<b>Advisory Action</b> <b>Before the Filing of an Appeal Brief</b>	Application No. 10/772,524	Applicant(s) LLOYD, JEFFREY	
	Examiner Devon C. Kramer	Art Unit 3683

THE REPLY FILED 20 January 2006 FAILS TO PLACE THIS APPLICATION IN CONDITION FOR ALLOWANCE.

**AIR SPRING WITH ADDITIONAL VOLUME**  
[Luftfeder mit Zusatzvolumen]

Fig.1

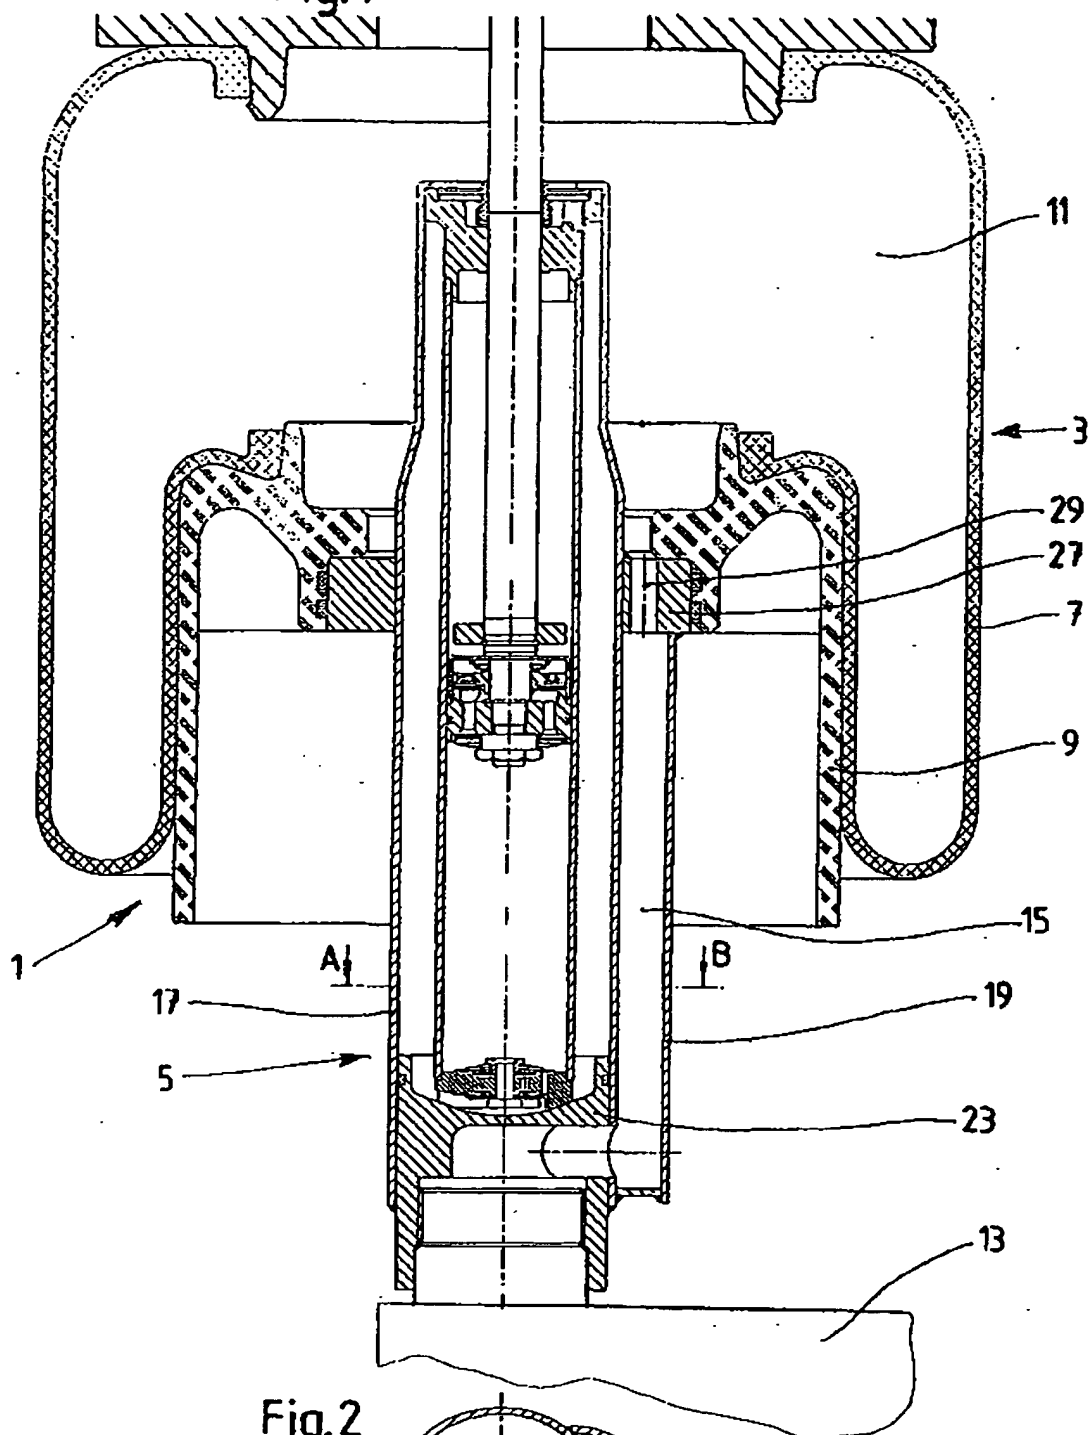
Continuation of 11. does NOT place the application in condition for allowance because: Applicant argues that element 9 is not a flexible material. Please note that element 9 is disclosed as a roll-off piston and is depicted as an elastomer material . .
